Report to the Future Melbourne (Planning) Committee

**Planning Permit Application: TP-2017-395
137-157 Adderley Street, West Melbourne**

16 October 2018

LOWER GROUND & MEZZANINE

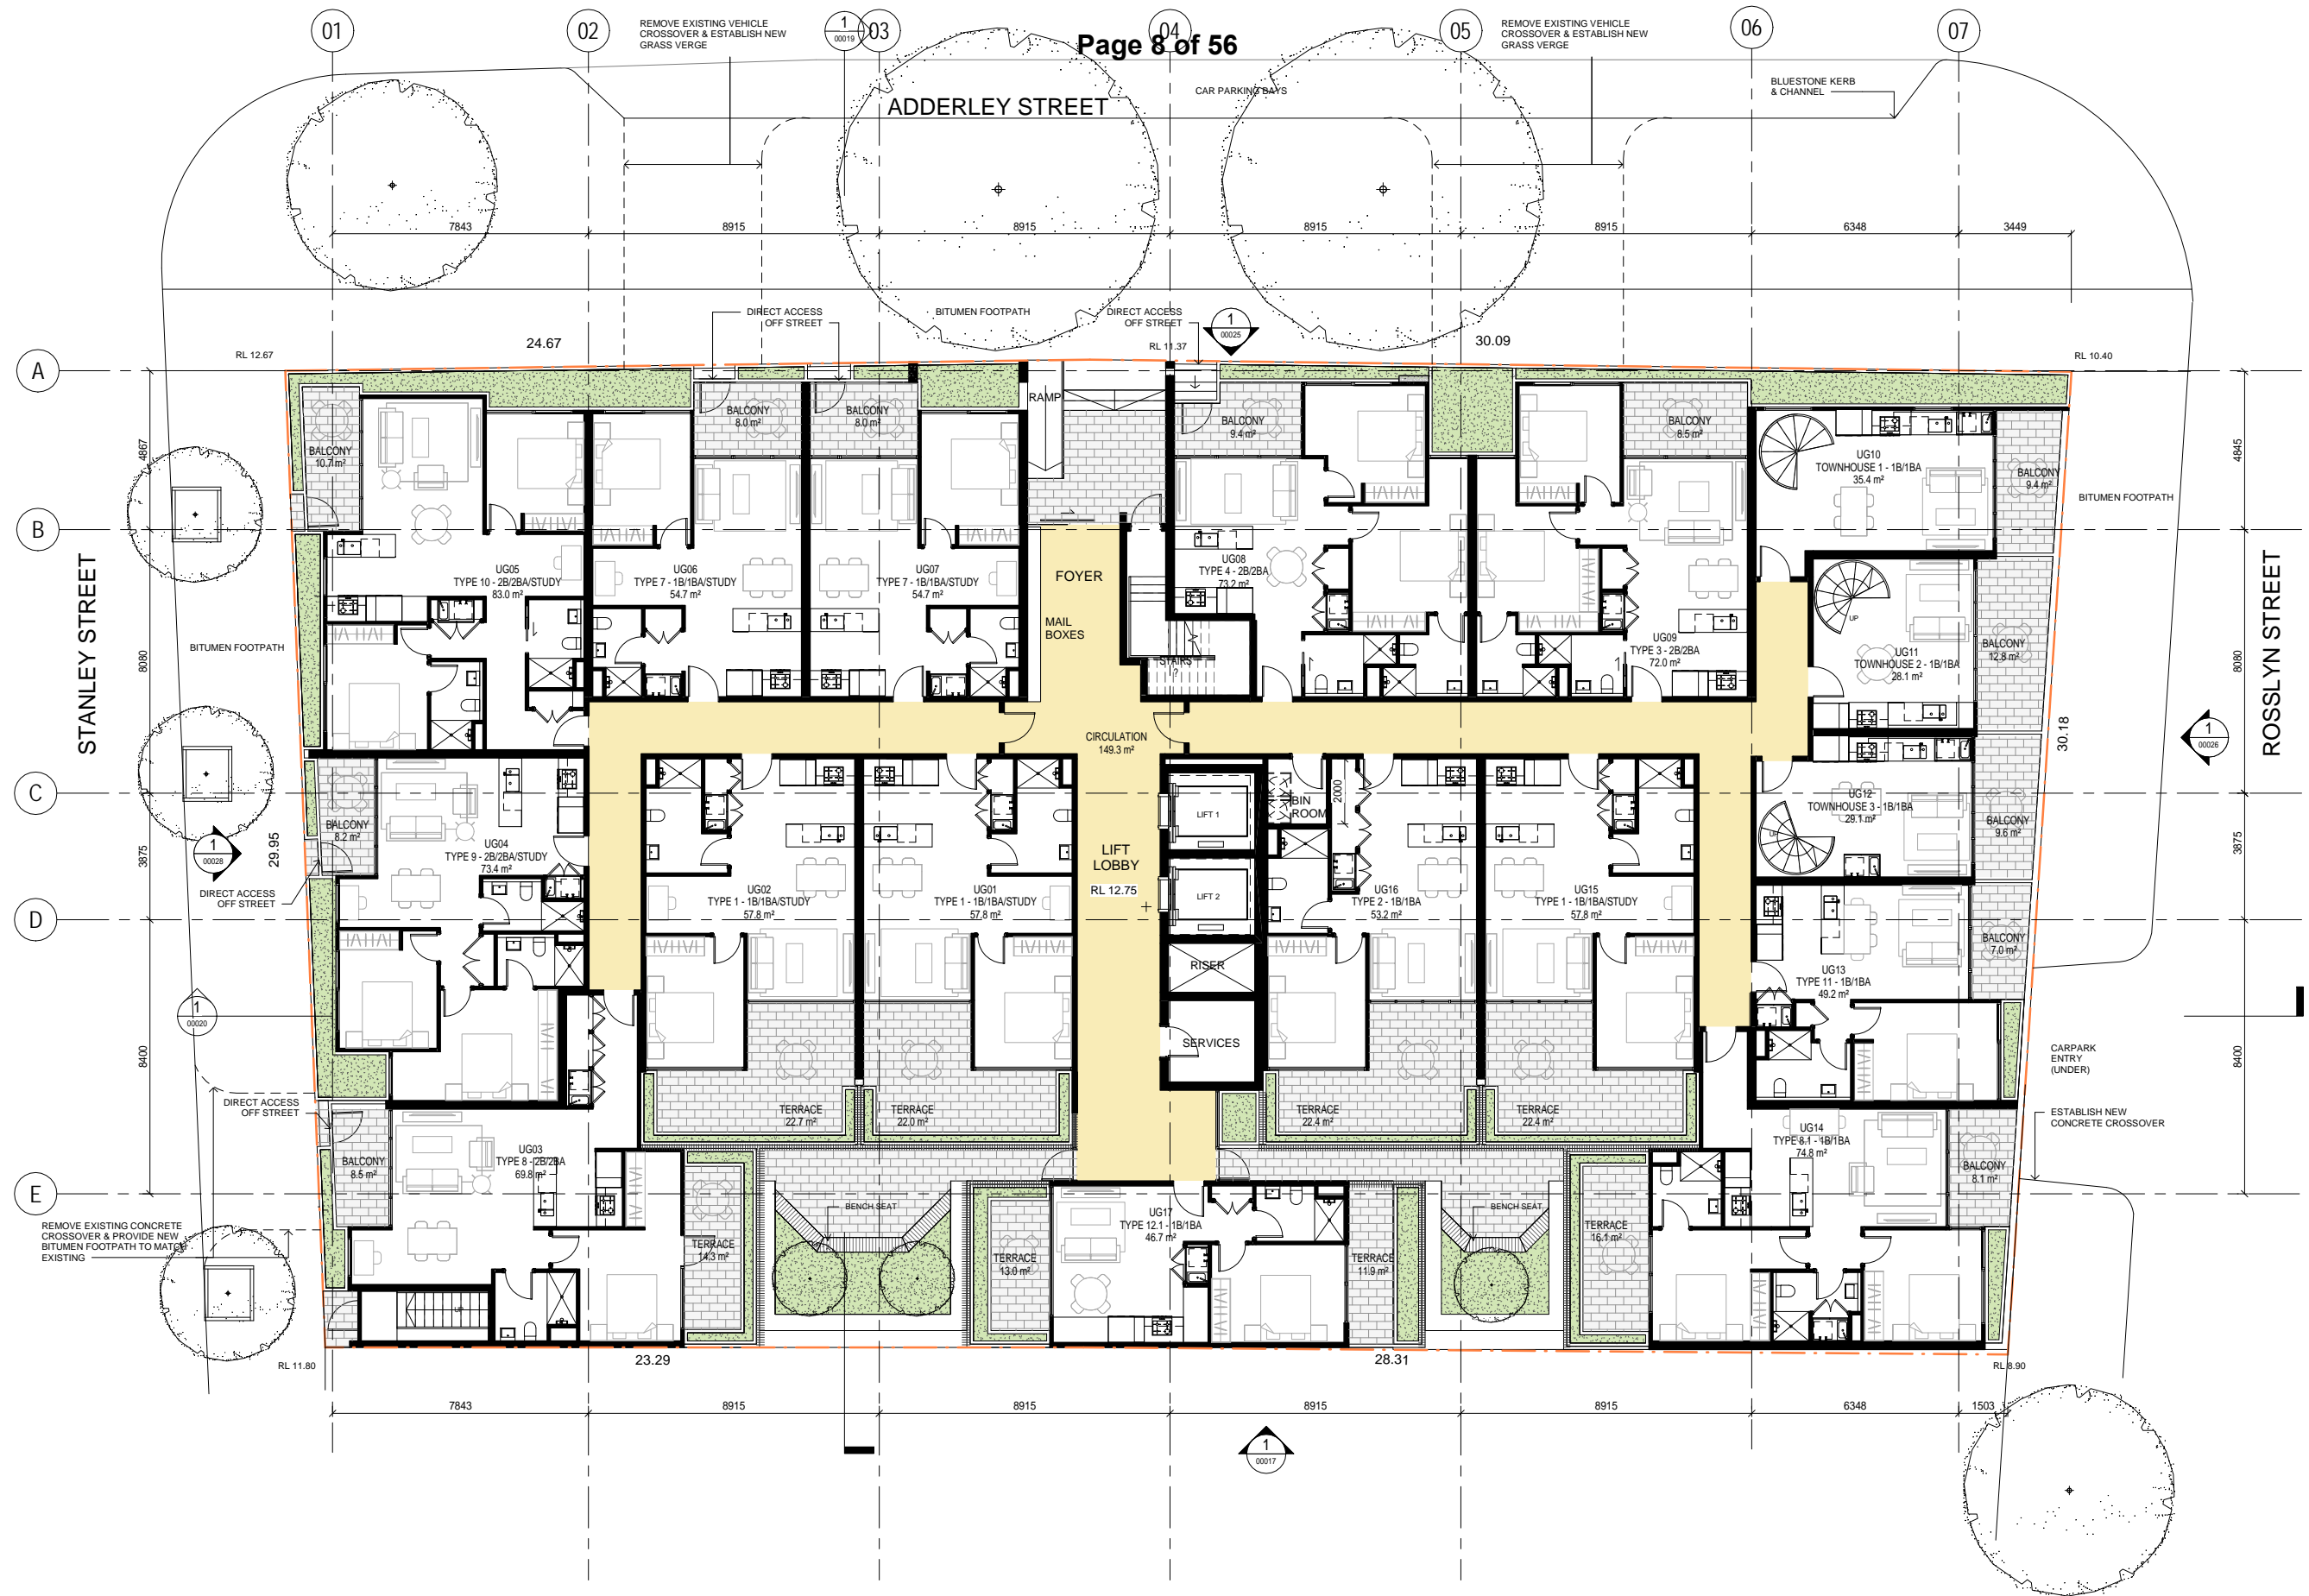
The without prejudice lower ground floor plan and section AA received 3 October 2018 were referred to Traffic who advised that:

The without prejudice revised plans received 3 October 2018 reduce the number of car parking spaces from 100 to 94 to accommodate the 2.6m wide x 8.8m long loading bay. This change equates to an oversupply of nine spaces.

While there is no requirement to provide on-site loading, a 'resident loading bay' is provided and the without prejudice revised plans received 3 October 2018 include a 2.6m wide x 8.8m long x 4m high loading bay for on-site garbage collection.

- a) Relocation of the substation and vehicle access/egress on Rosslyn Street and provision of a 2.6m wide x 8.8m long x 4m high loading bay for on-site garbage collection as shown on the without prejudice revised plans received 3 October 2018. These changes must not increase the height of the building at any point or result in the loss of more than 6 car parking spaces.

UPPER GROUND FLOOR

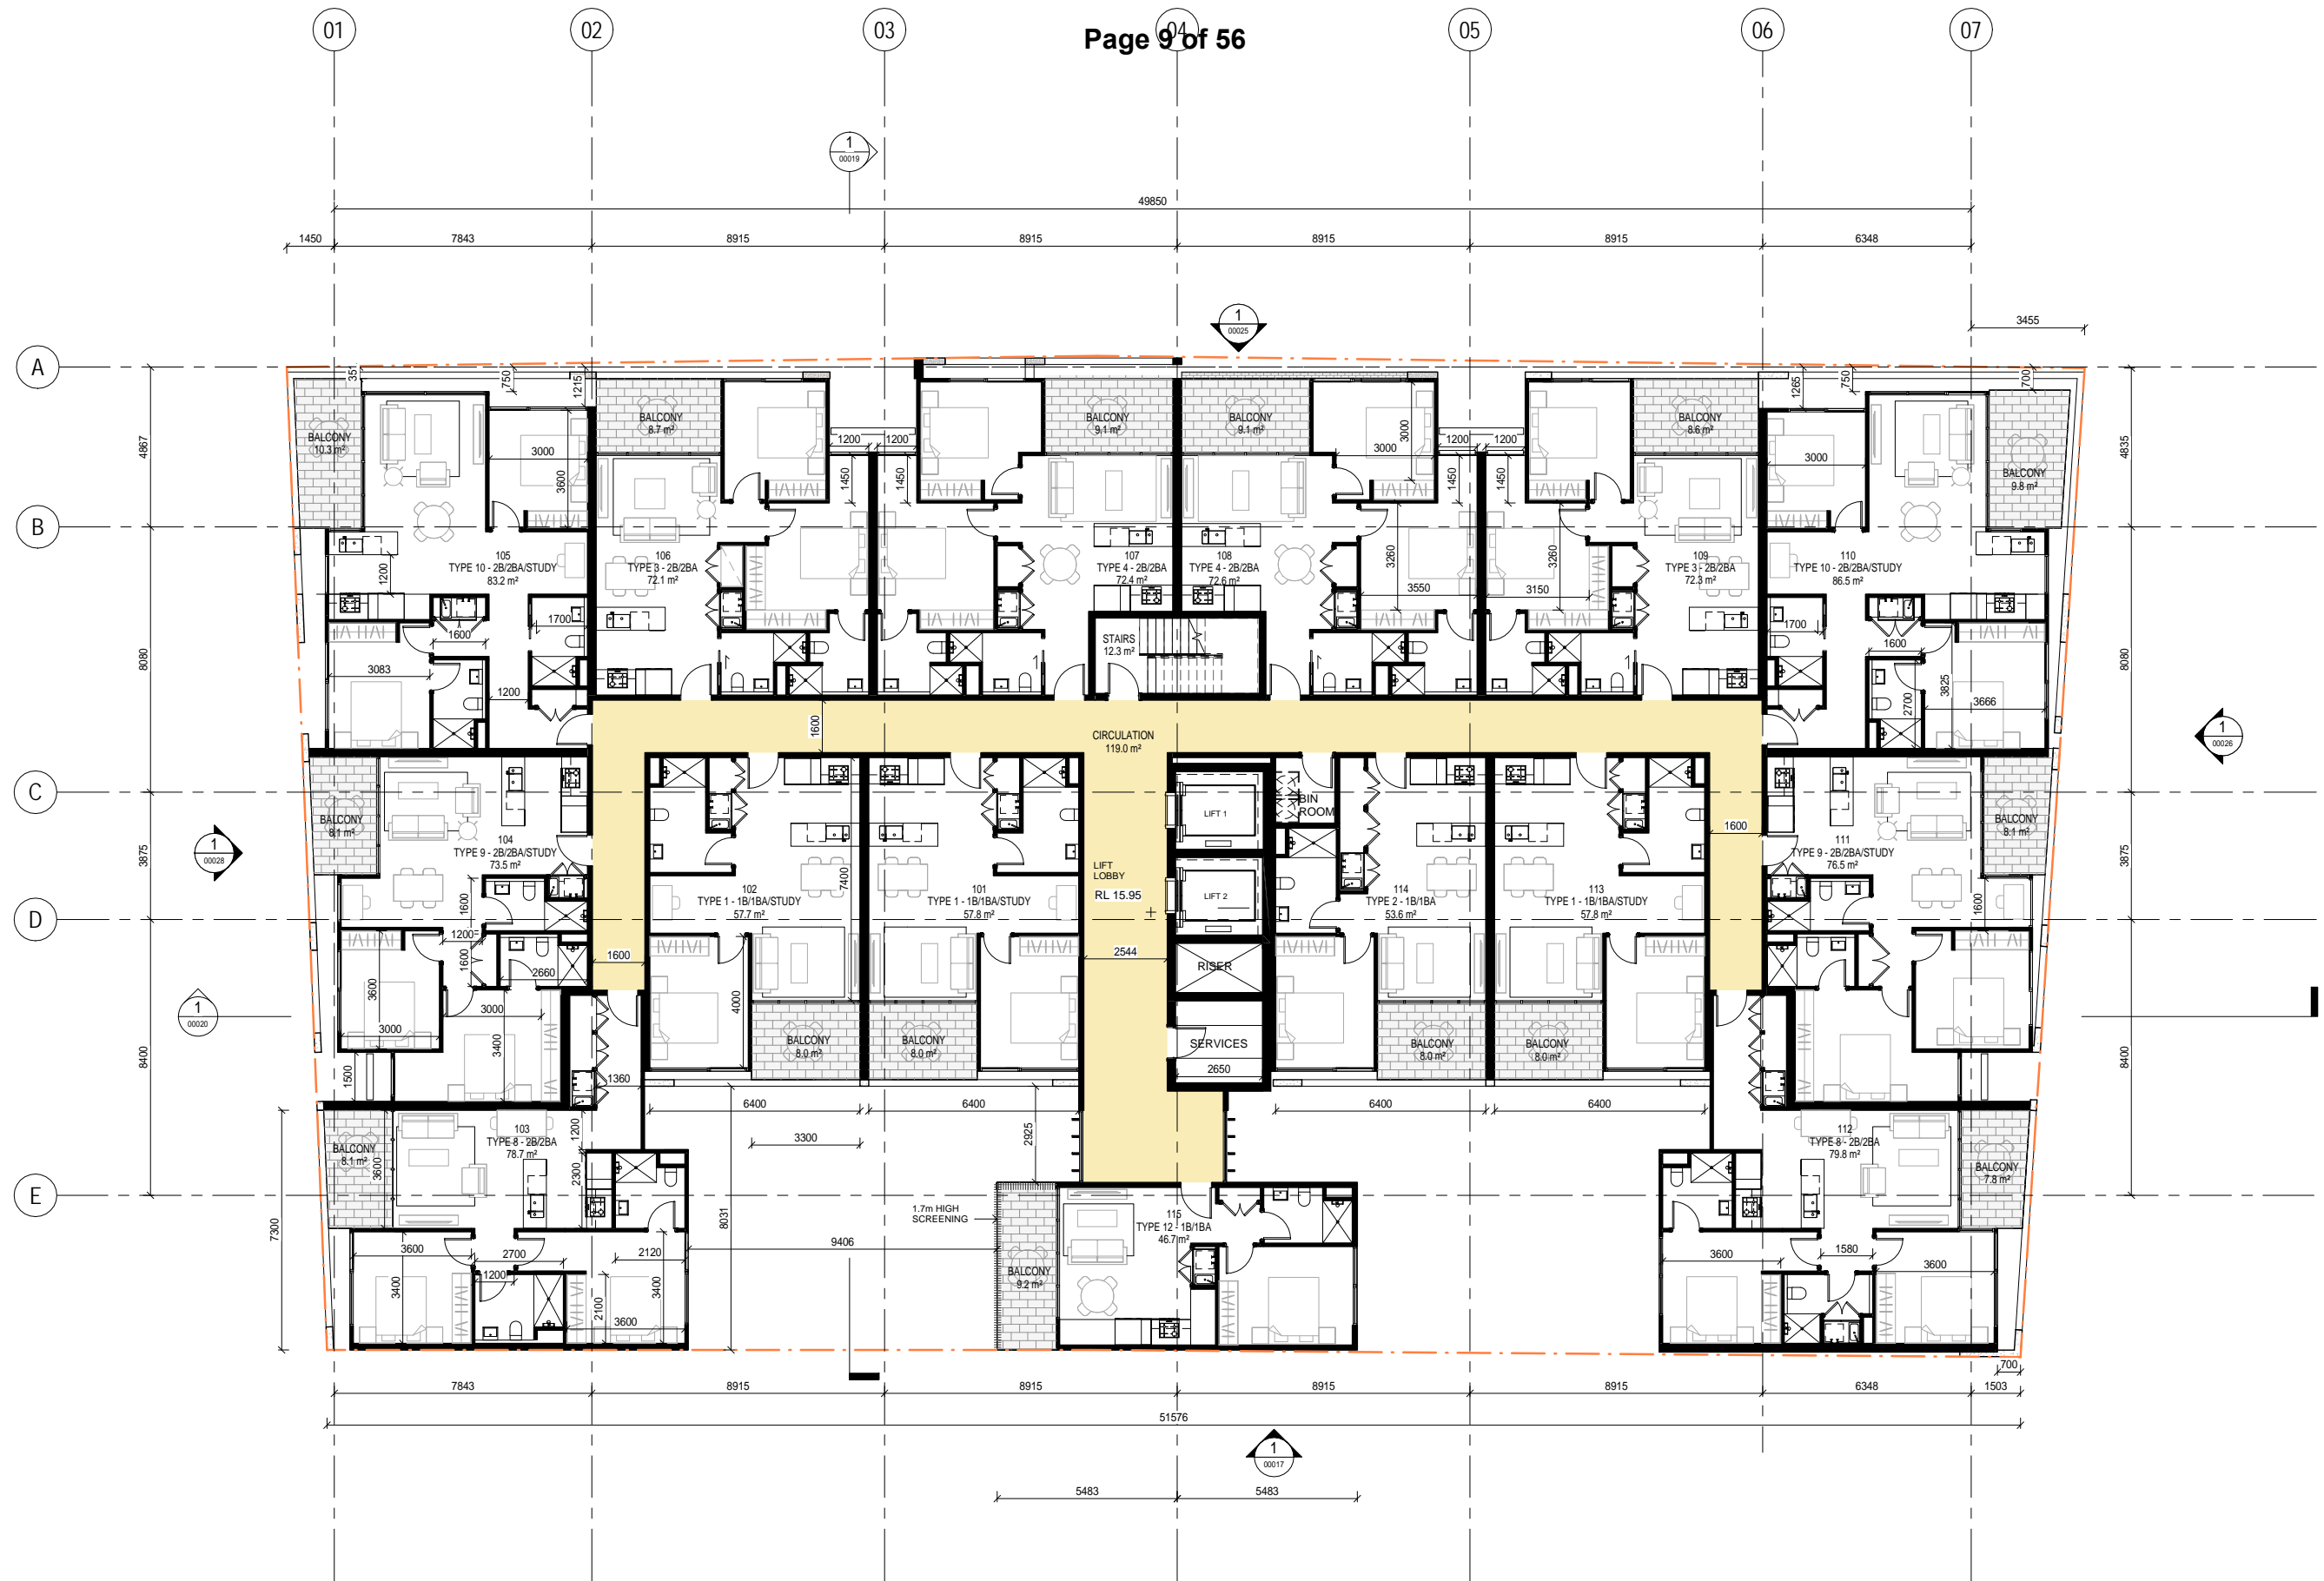
9. The development generally complies with the objectives and standards of Clause 58. Conditions are recommended to delete dwelling nos. 17, 115, 215 and 315 and consolidate the communal open space on the upper ground floor adjoining the southwest boundary. This change will remove the compromised dwellings with no visual connection to the external environment, improve the light and outlook of the single-aspect southwest-facing dwellings, and improve the practicality and attractiveness of the communal open space on the upper ground floor.

- Delete the nib wall on the upper ground floor to Dwelling 10 (Townhouse 1) and extend the balcony to the Adderley Street frontage.
 - Break-up the 26.2m long x 2.6-3.6m high wall on Adderley Street by providing wrought iron metal balustrades to the balconies on upper ground level to Dwellings 8, 9 and 10 (Townhouse 1).

316031 ADDERLEY STREET APARTMENTS,
LOWER AND GROUND MEZZ PLAN
PROPOSED WASTE TRUCK LOCATION.
TB4 02/10/18
1:200@A3

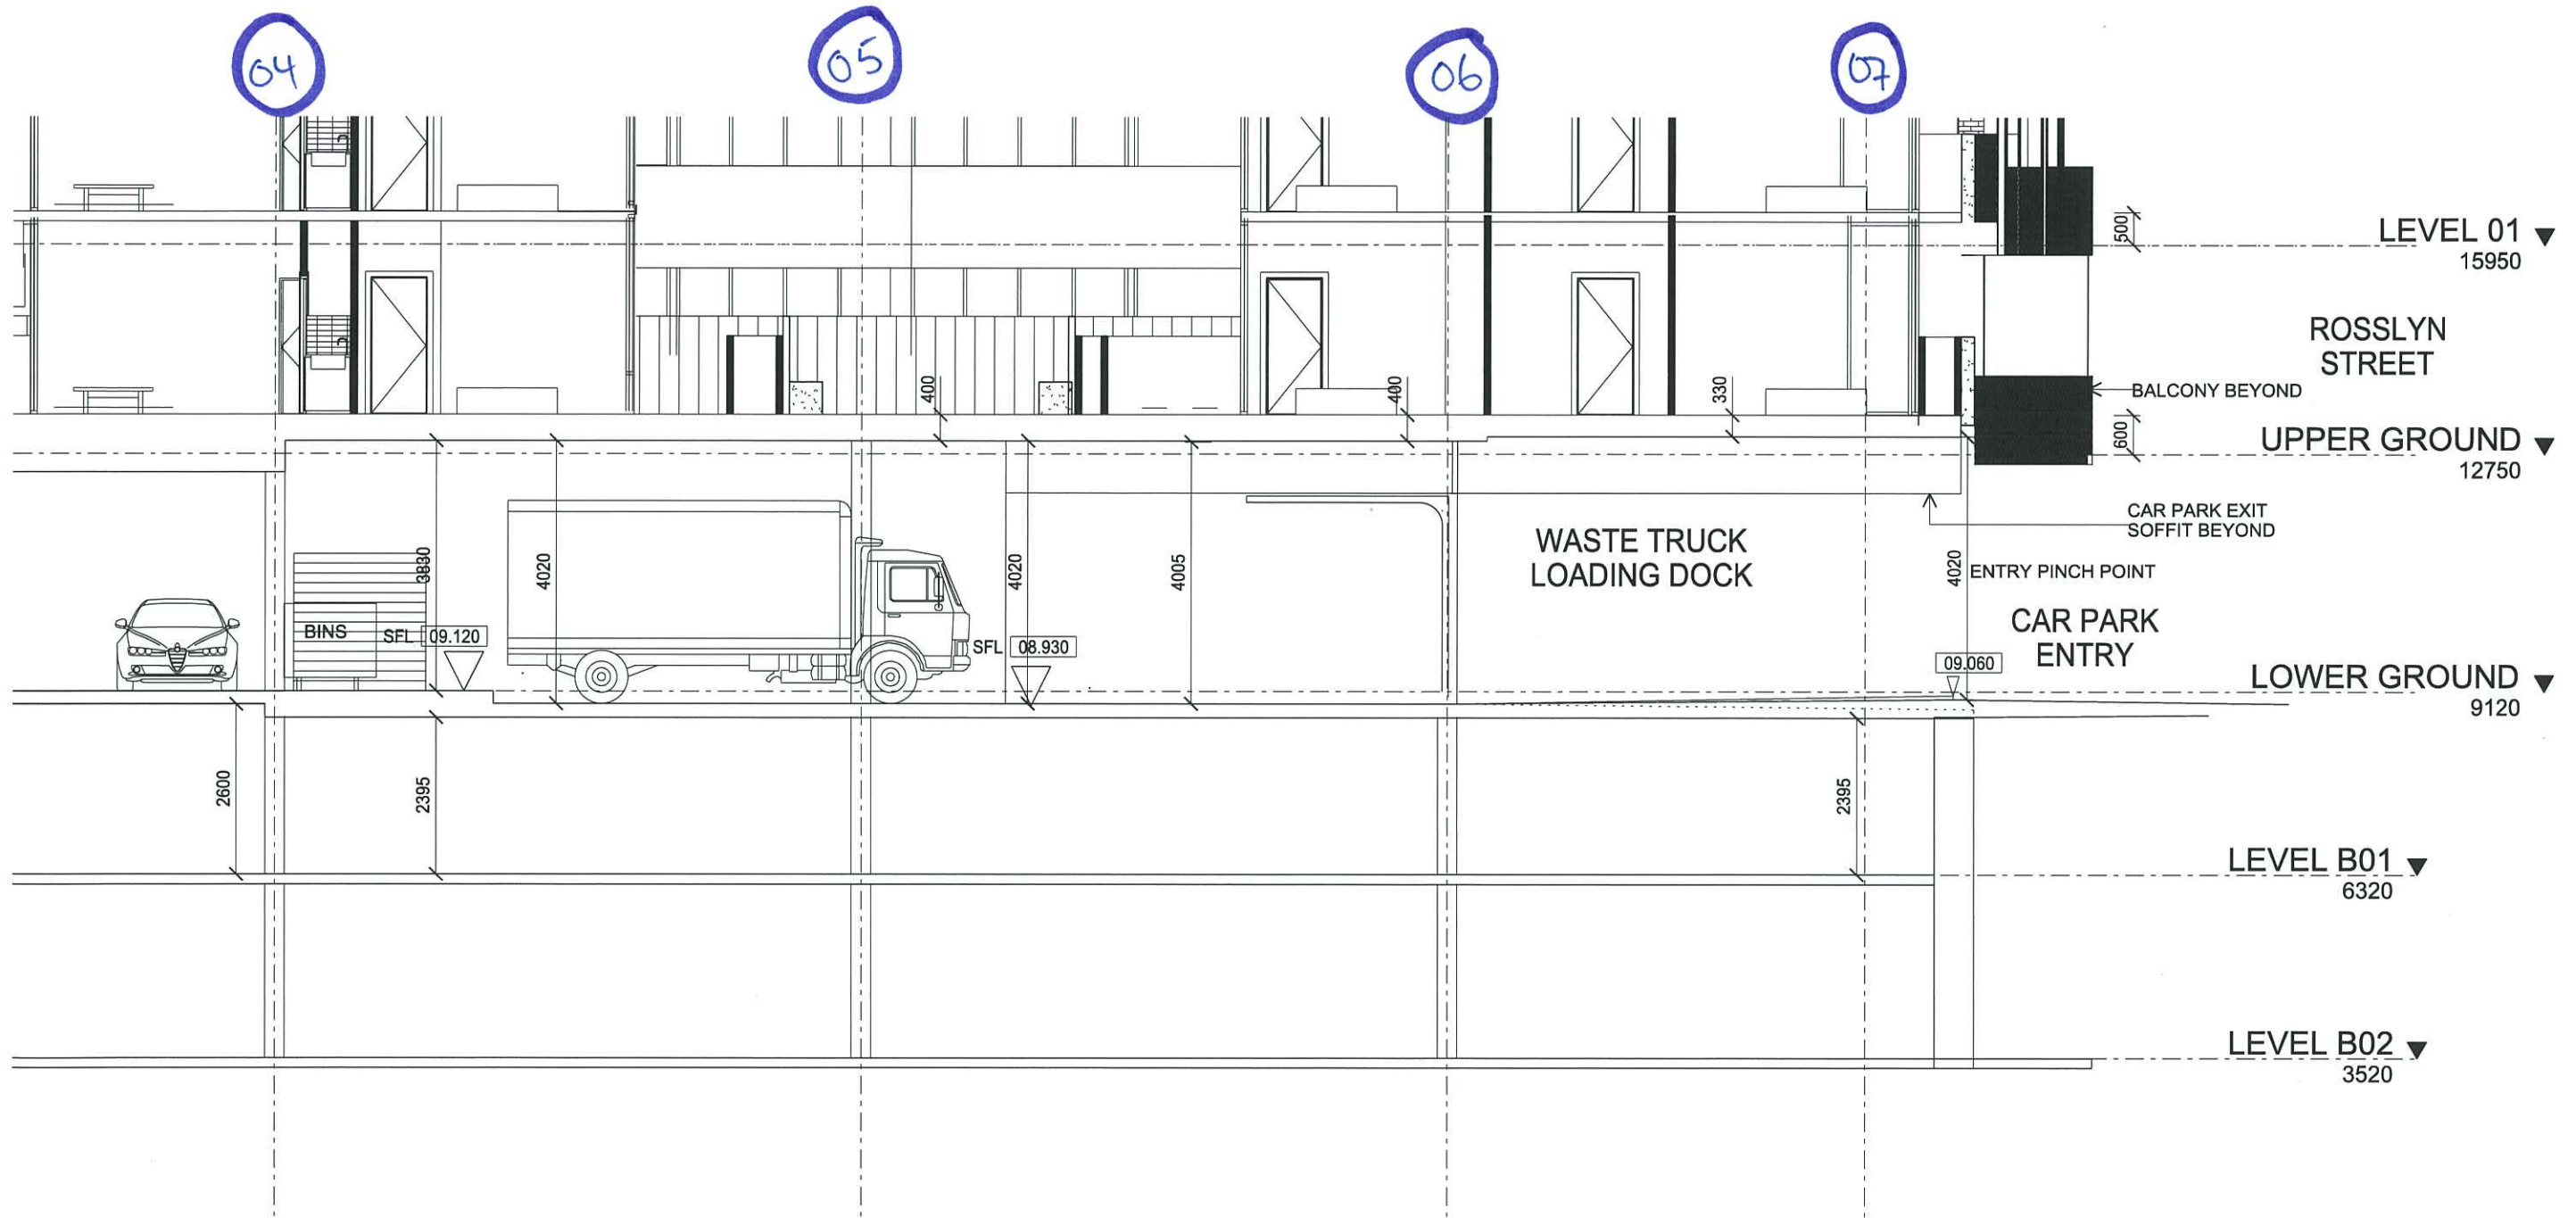
The without prejudice WMP and revised plans, received 27 September and 3 October 2018, were referred to Waste who advised that:

- The revised documents are acceptable subject to swept path diagrams to show that the truck can safely enter and exit the site.
